## STAGE 1 & 2 ROAD SAFETY AUDIT REPORT FOR SITE H30, PERTH ROAD, STANLEY, PERTHSHIRE.

Report Ref 85820(1&2)

Site H30, Perth Road, Stanley, Perthshire.  
Road Safety Audit Stage 1&2

Perth Road, Stanley.

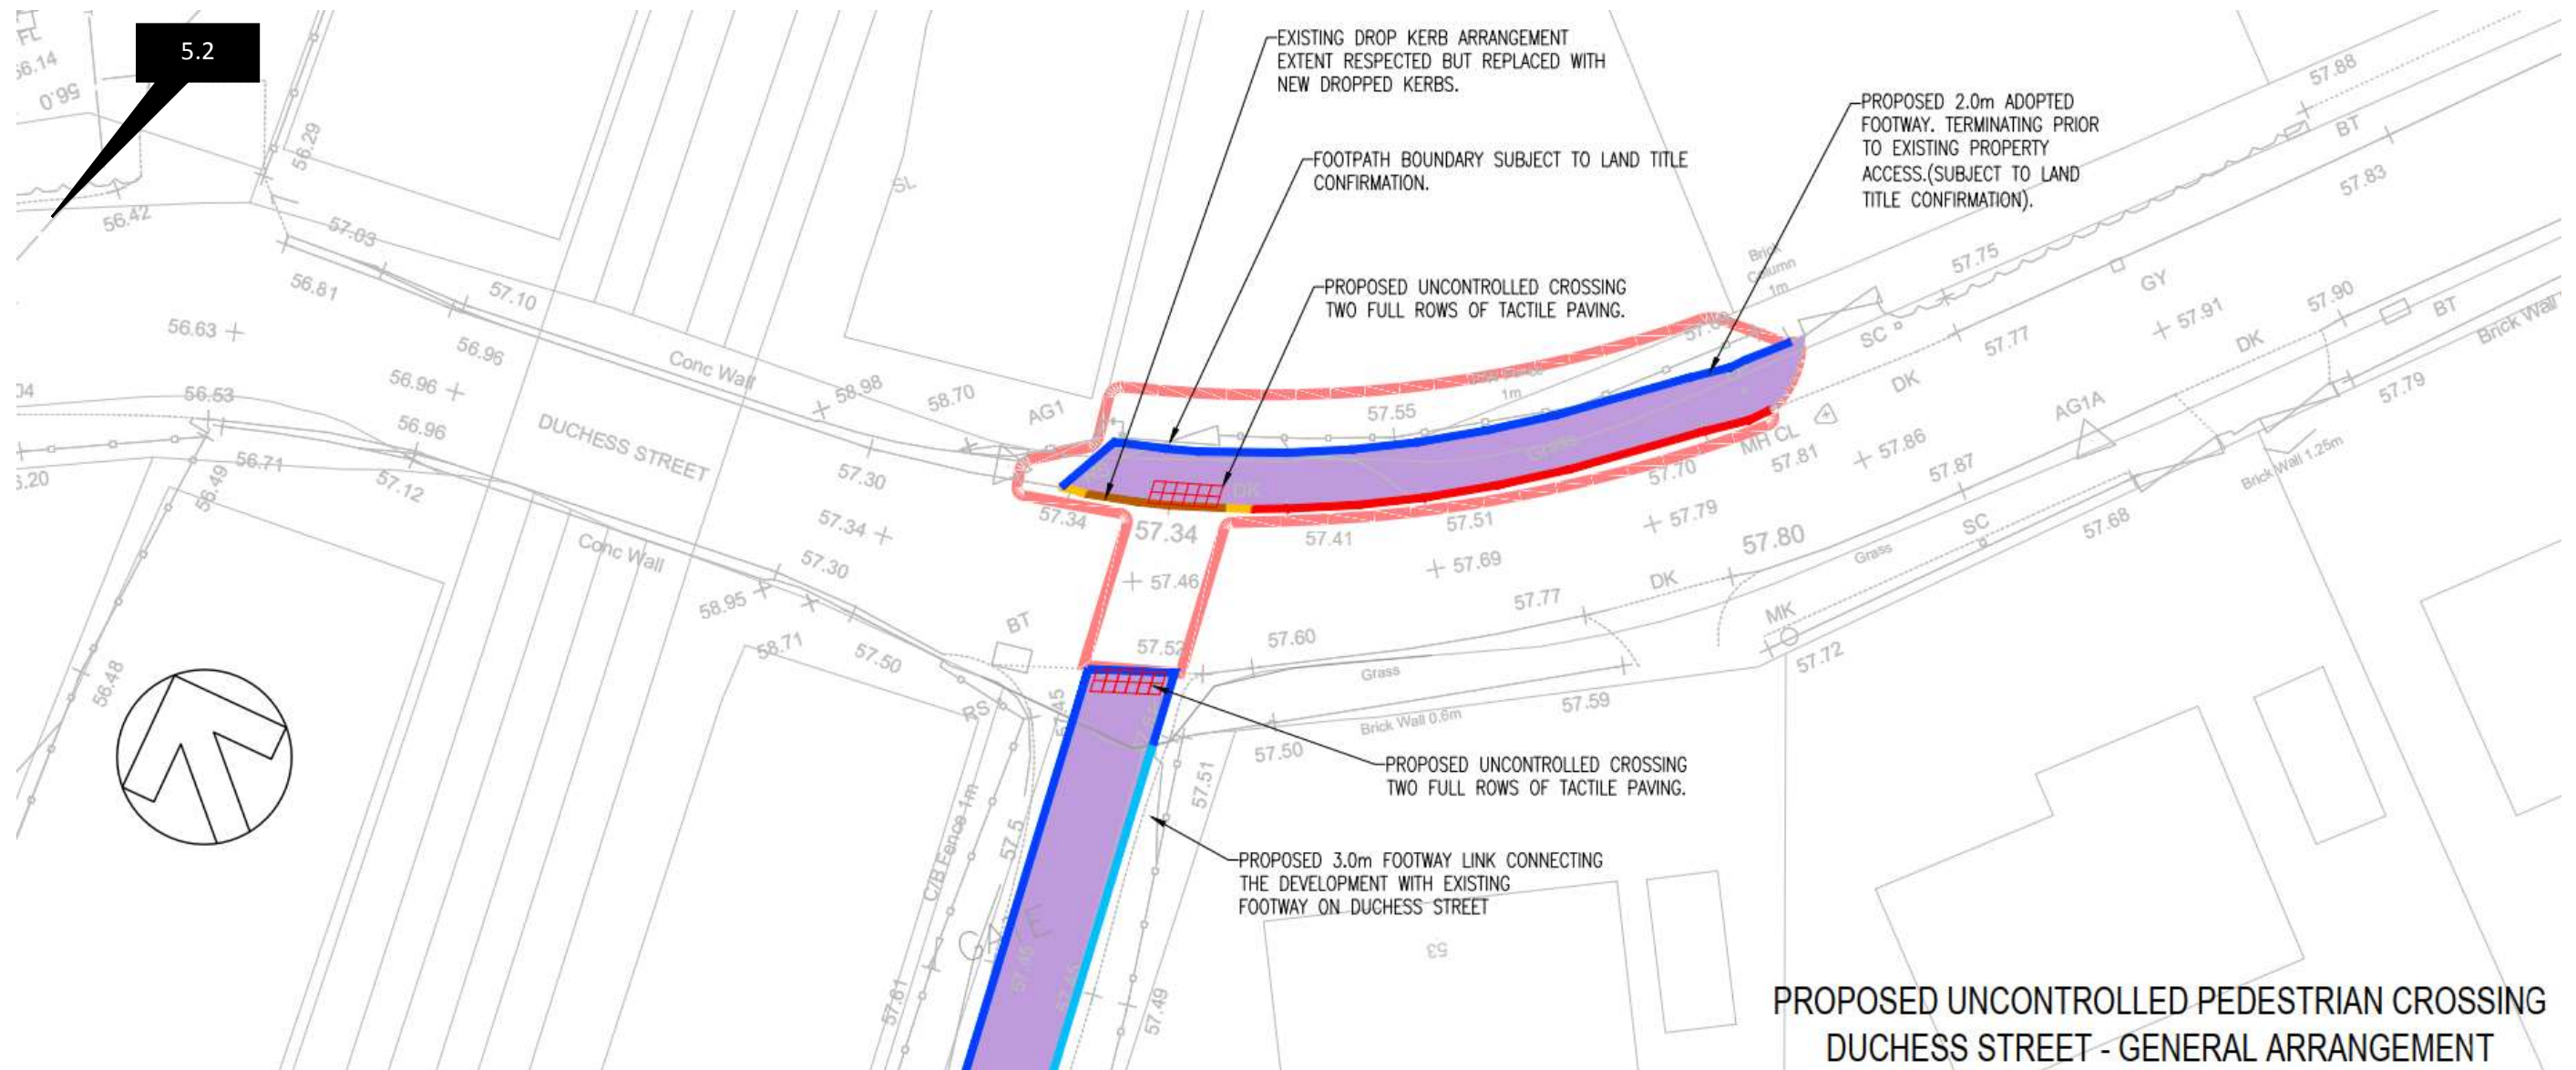
The carriageway is to be widened on its west side and a footway added. This will give a greater surface area to be drained. When heading north the road profile falls away from the new junction towards a tight right hand bend. The additional carriageway width could result in additional surface water crossing the carriageway towards the road gullies at the bend. During periods of heavy rainfall this could result in excessive surface water crossing the carriageway which may contribute to aquaplaning type collisions.

Sightlines between eastbound approaching drivers and pedestrians at the uncontrolled crossing point are restricted by the concrete parapets of the adjacent railway bridge. The eastbound approach road alignment towards the bridge has a tight right hand bend which limits approaching speeds. Drivers however may not see, nor expect, pedestrians waiting to cross the road immediately on the west side of the bridge. This could result in a pedestrian stepping out into the path of an eastbound vehicle, resulting in a serious injury collision.

A new junction and altered alignment will generate new turning manoeuvres that some drivers may not expect to encounter. There is a risk that approaching drivers who are not aware of the new junction or road alignment will not adjust their speed accordingly and this could lead to a loss of control type collision.

It is recommended that the additional carriageway width and footways are drained towards the development and not across the carriageway in advance of the bend.

1. The drop kerbs and tactile paving on the north kerblines are positioned to optimise sightlines between pedestrians and eastbound drivers.
2. A danger ahead warning sign (Diag 562) with a "Pedestrians Crossing" sub-plate is provided on the eastbound approach to the crossing point.

It is recommended that temporary New Road Layout Ahead signs (Diag 7014)<sup>2</sup> are provided on both approaches.
